SERVICE BULLETIN

N° **139-731**

DATE: October 11, 2022

ATA 00 – FORWARD CABIN ROOF CEILING HARNESS INSPECTION

Figure 1

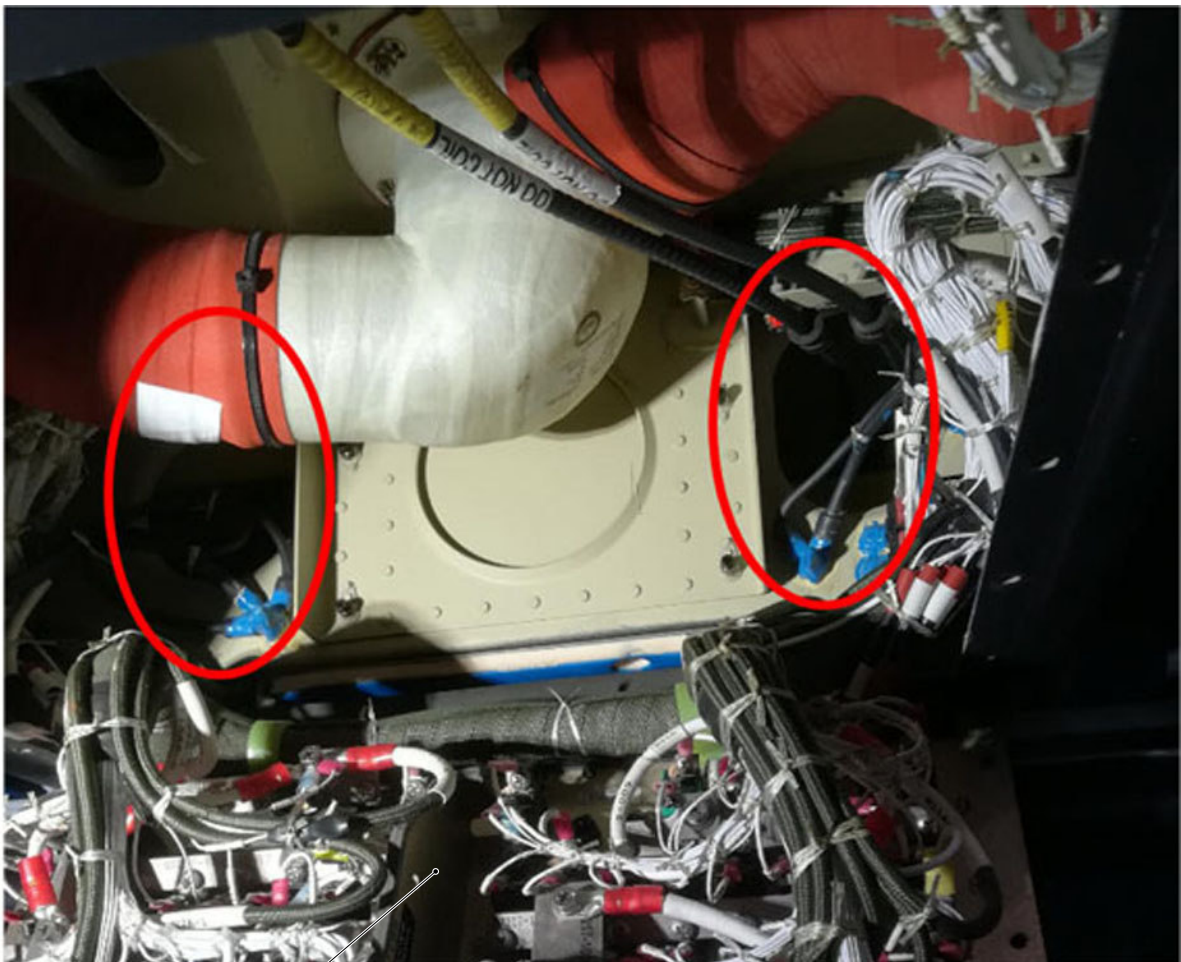
- 2.1.1 In accordance with the applicable steps of AMP DM 39-A-24-91-01-00A-520A-A and with reference to Figure 1, open the circuit breaker panel assy without removing it.

- 2.1.2 With reference to Figure 1, insert the borescope inside the lightening holes showed to access the area of the inspection.
 - 2.1.3 Perform a visual inspection of the C/As installation.

Figure 3

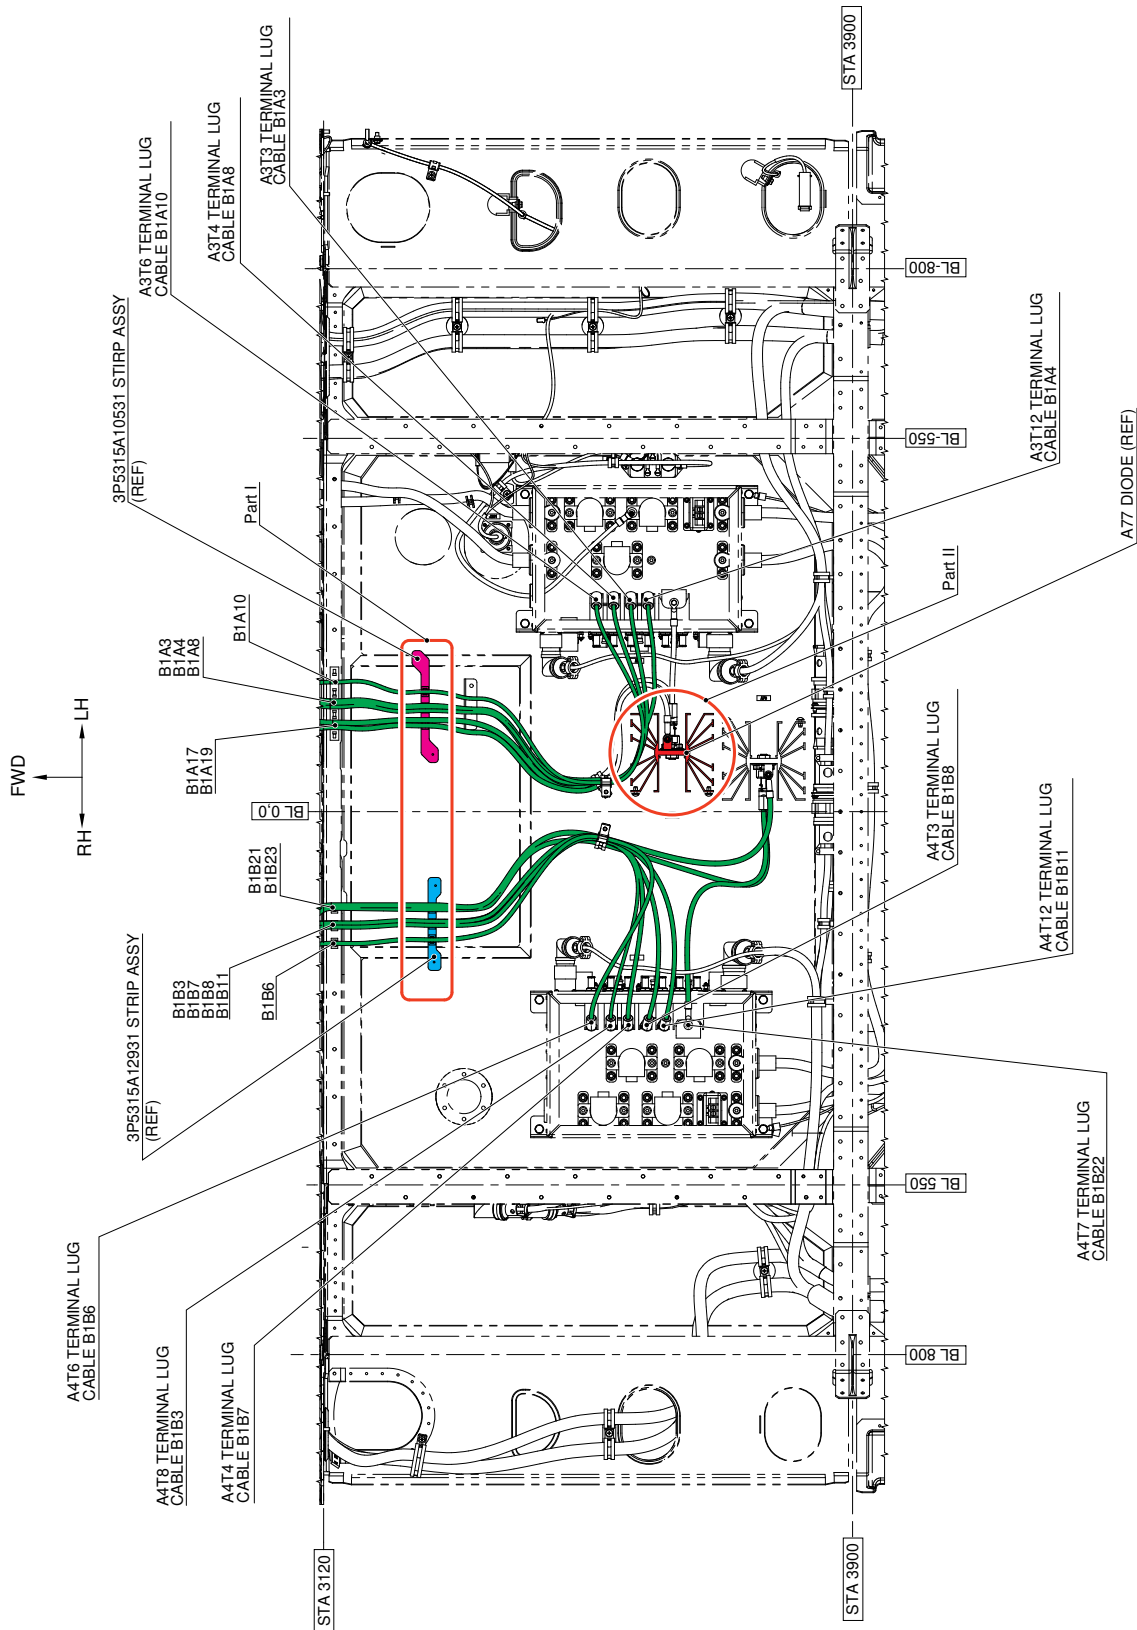
When C/A installation is correct, C/A are installed below the RH/LH strips P/N 3P5315A10531 and P/N 3P5315AA12931, as shown in Figure 3.

- 2.1.4 If C/As are installed above the strips P/N 3P5315A10531 and/or P/N 3P5315A12931 as per Figure 4 “Incorrect Installation”, go to step 3.
- 2.1.5 If C/As are installed correctly as shown in Figure 3, go to step 5 and close SB Part I application.

Figure 6

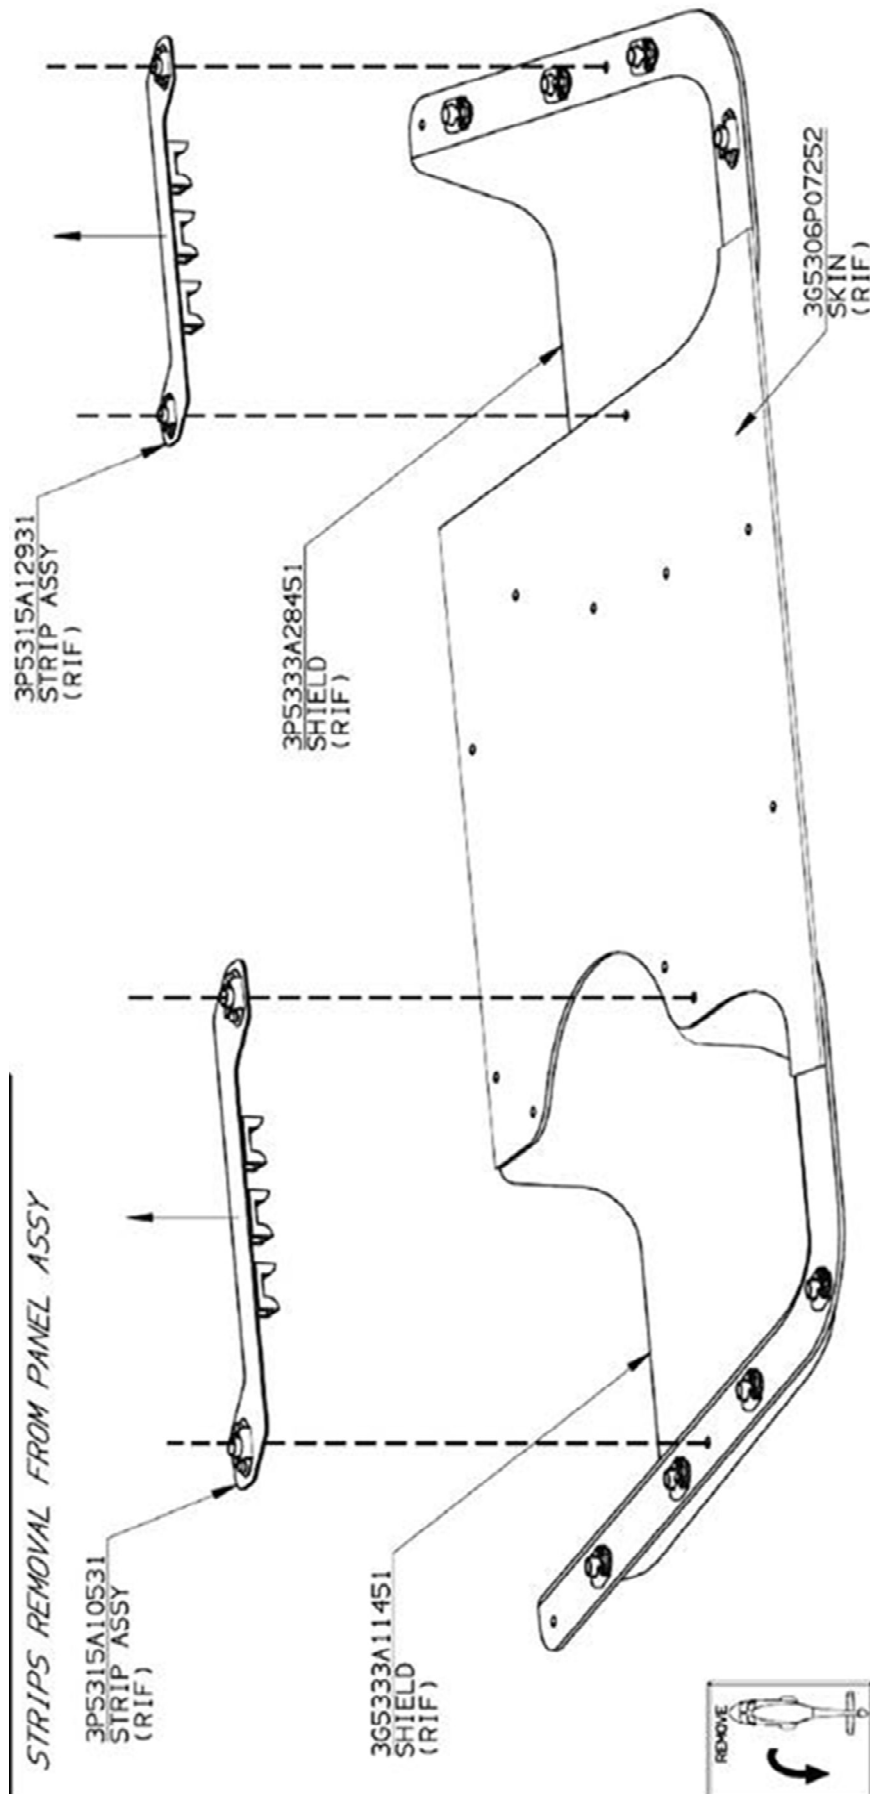
- 3.3.2 With reference to Figure 6 remove strips P/N 3P5315A10531 and/or 3P5315A12931 and put them on a workbench. Retain the fixing hardware for later use.

3.3.7 With Reference to Figure 6, reinstall strips P/N 3P5315A10531 and/or 3P5315A12931.

Figure 7

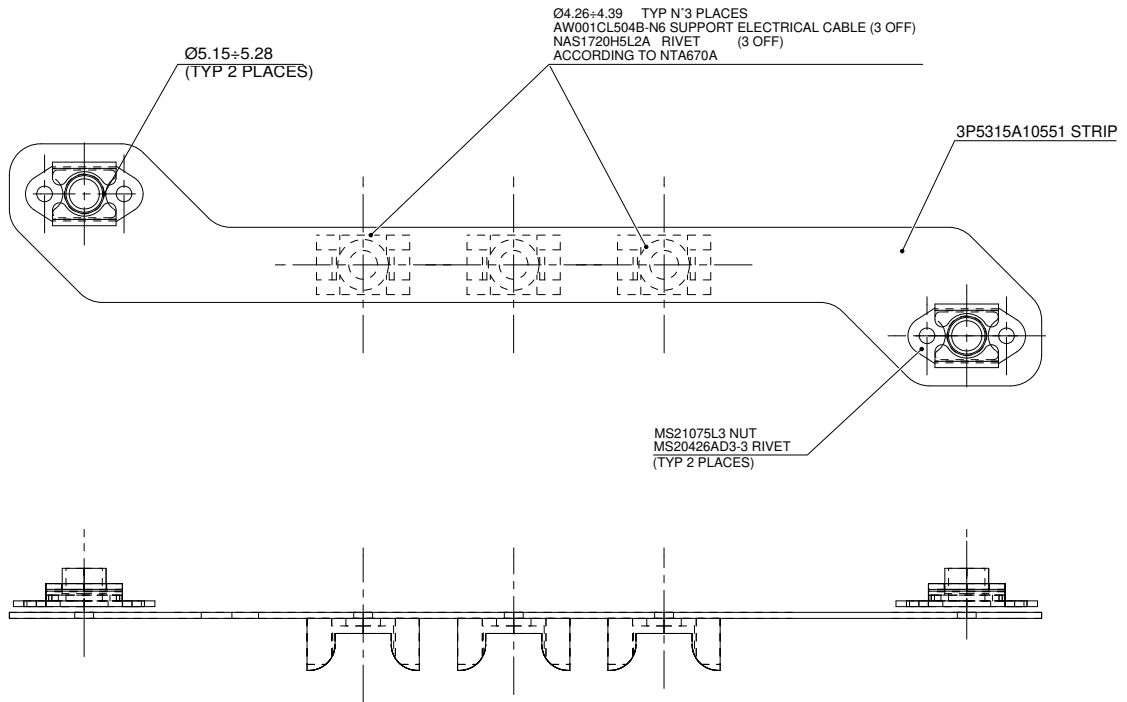
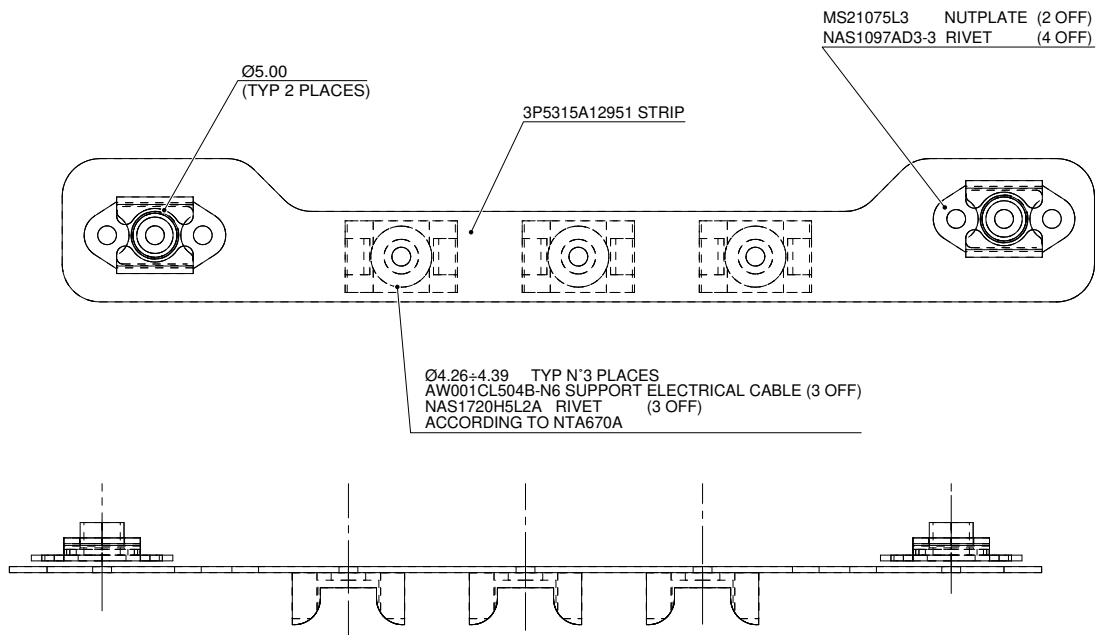
- 3.3.3 With reference to Figure 7, remove n° 3 supports AW001CL504B-N6 from P/N 3P5315A10531 and/or P/N 3P5315A12931.

- 3.3.4.4 With reference to Figure 7 install n°2 nut plates P/N MS21075L3N by means of n°4 rivet P/N NAS1097AD3-3 or P/N MS20426AD3-3 (as applicable) on strips P/N 3P5315A10551 and/or 3P5315A12951.

- 3.3.4.5 With Reference to Figure 7, install n° 3 new supports AW001CL504B-N6 by means of n° 3 rivets NAS1720H5L2A on strips P/N 3P5315A10551 and/or 3P5315A12951. Make sure they are oriented opposite with respect to nut plates MS21075L3N.

- 3.3.4.6 With reference to Figure 7, countermark the obtained components as P/N 3P5315A10531 and/or 3P5315A12931.

- 3.3.5 With Reference to Figure 7, install n° 3 supports P/N AW001CL504B-N6 by means of n° 3 rivets NAS1720H5L2A on bracket P/N 3P5315A10531 and/or 3P5315A12931. Make sure they are oriented opposite with respect to nut plates MS21075L3N.
- 3.3.6 With reference to Figure 9, fix C/As on strips P/N 3P5315A10531 and/or 3P5315A12931 by means of tie wraps.

Figure 10

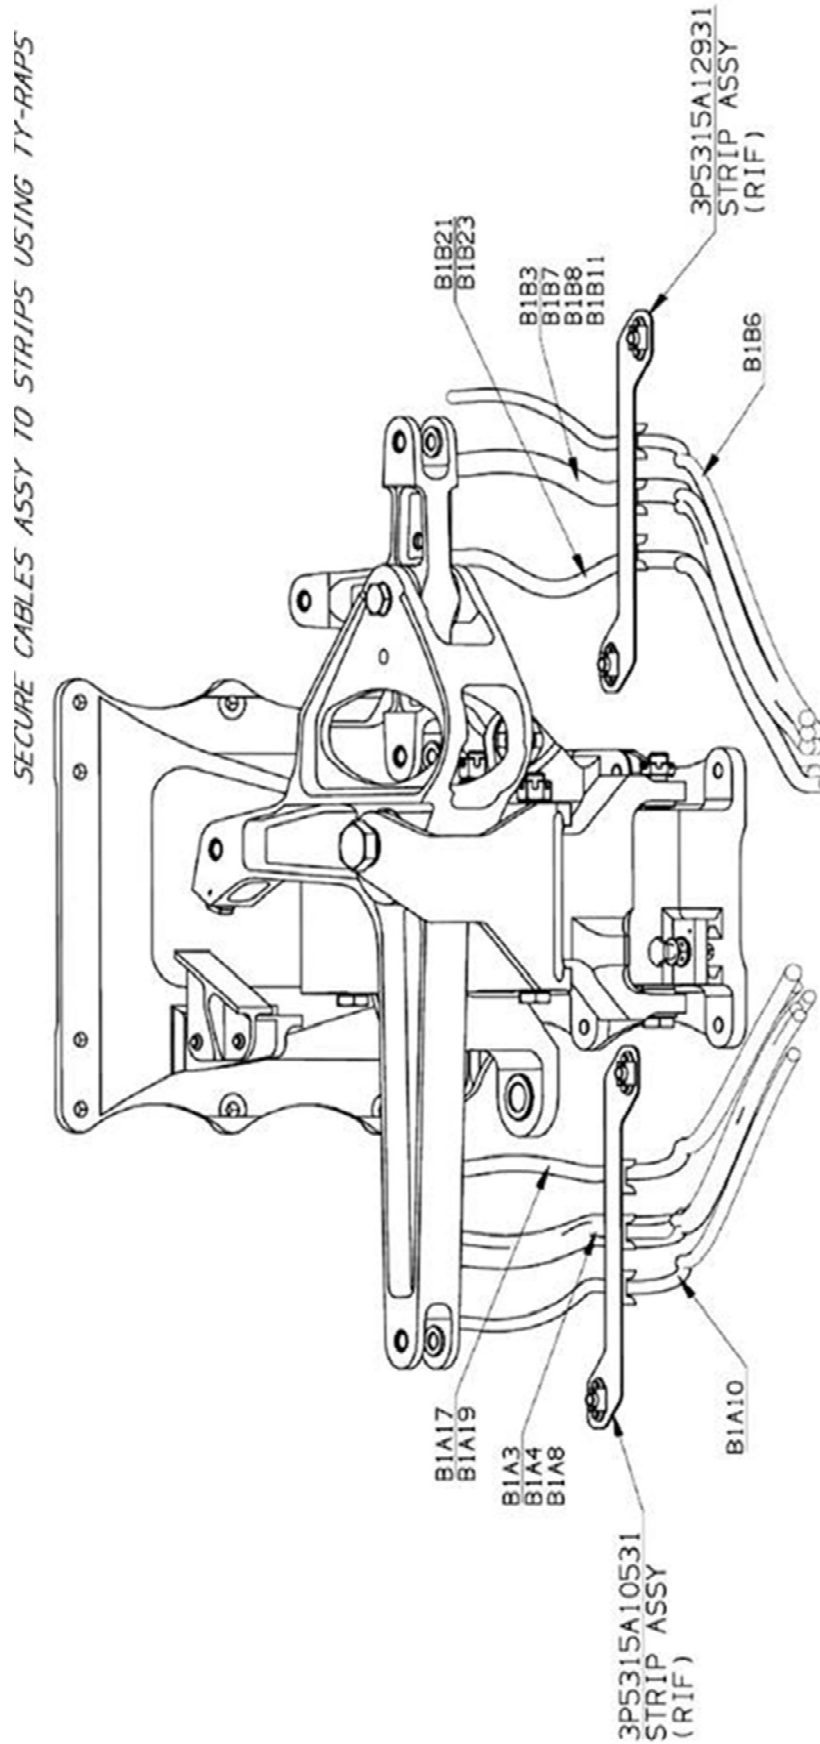
- 2.1.1 With reference to Figure 10, check for chafing or damage on the cable harness in the area showed.
 - 2.1.2 In case of any finding, contact Product Support Engineering (engineering.support.lhd@leonardo.com) in order to receive further instruction.

- 2.1.3 With reference to Figure 10 and Figure 11, ensure that clearance of at least 10.0 mm exists in the area inside the red circle shown in Figure 11, between the cable harness and Diode A77 P/N 3G2430V00352.

- 2.1.4 If necessary, in accordance with Figure 10 and Figure 11, re-route the cable harnesses (using if needed also lacing cord to fix the cables with each other) in order to respect the clearance of at least 10.0 mm from the diode or any other surrounding structure or component.

Figure 11

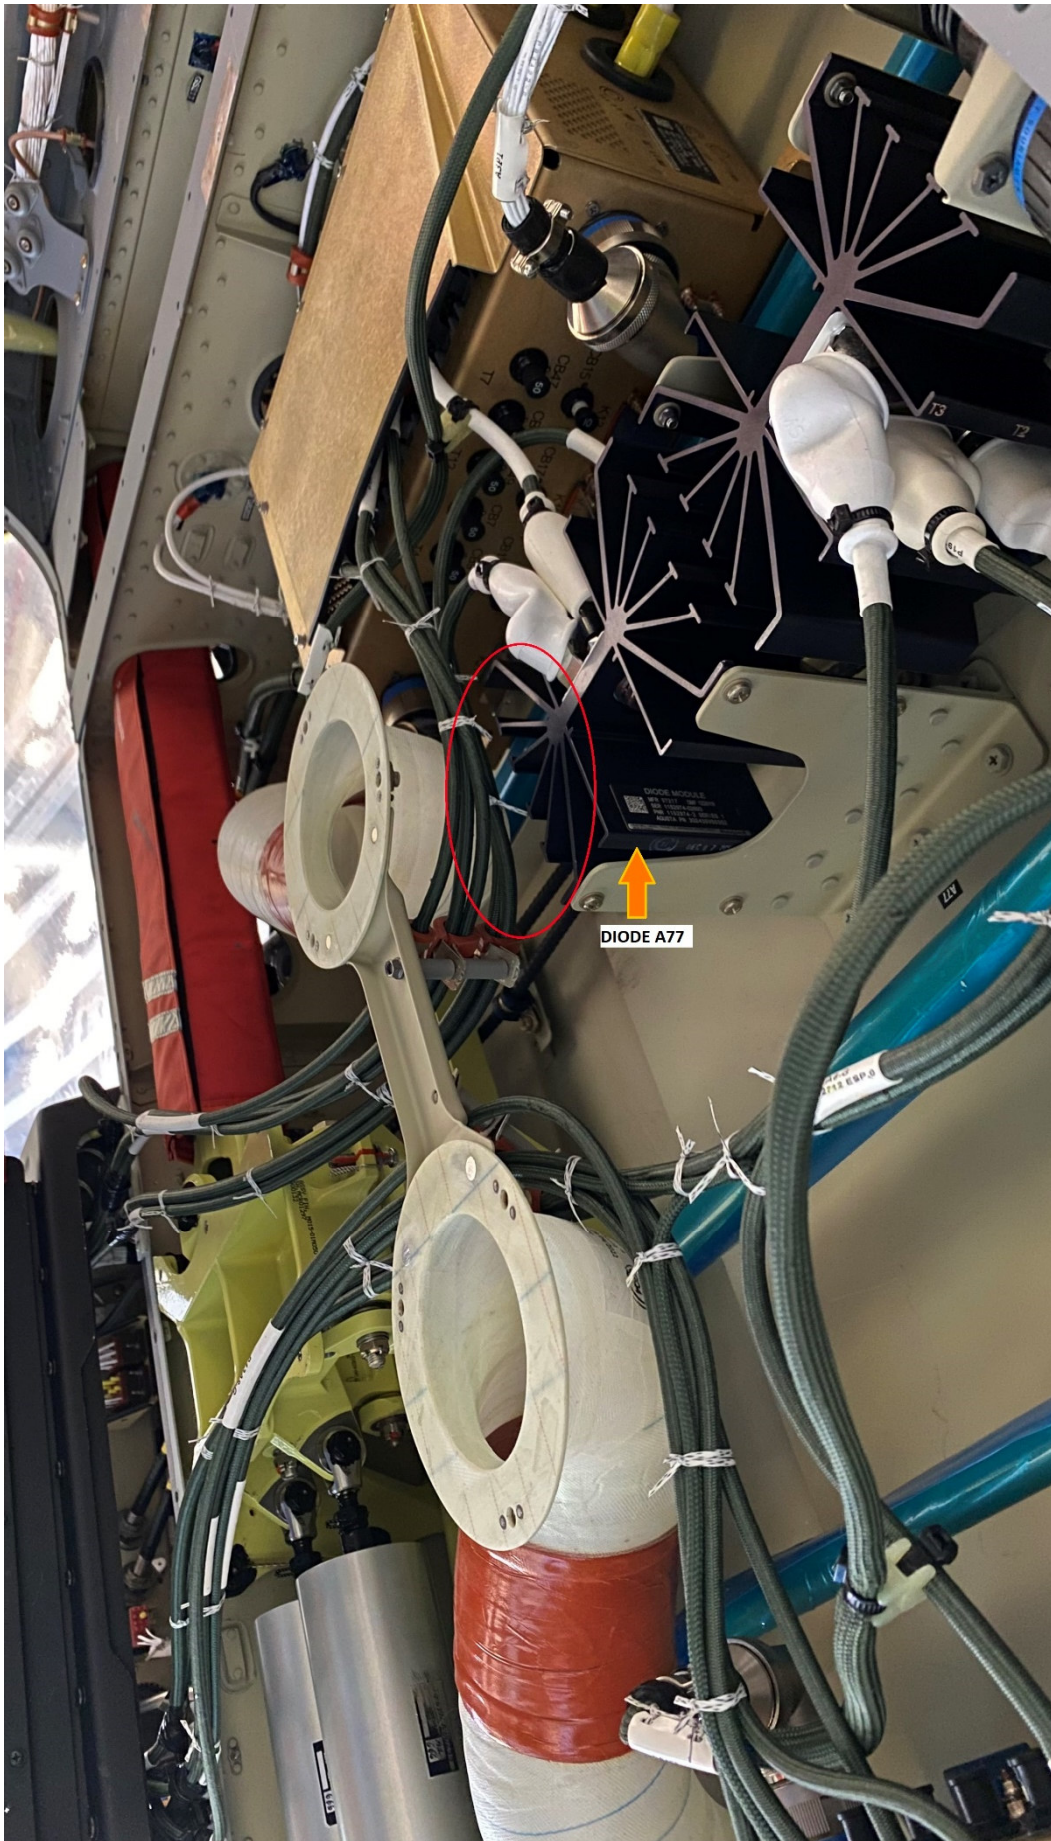
- 2.2 With reference to Figure 10 and 11, perform a visual inspection of the Diode A77. Make sure that no damage is present on the component.
 - 2.3 In case of any finding, contact Product Support Engineering (engineering.support.lhd@leonardo.com) in order to receive further instruction.
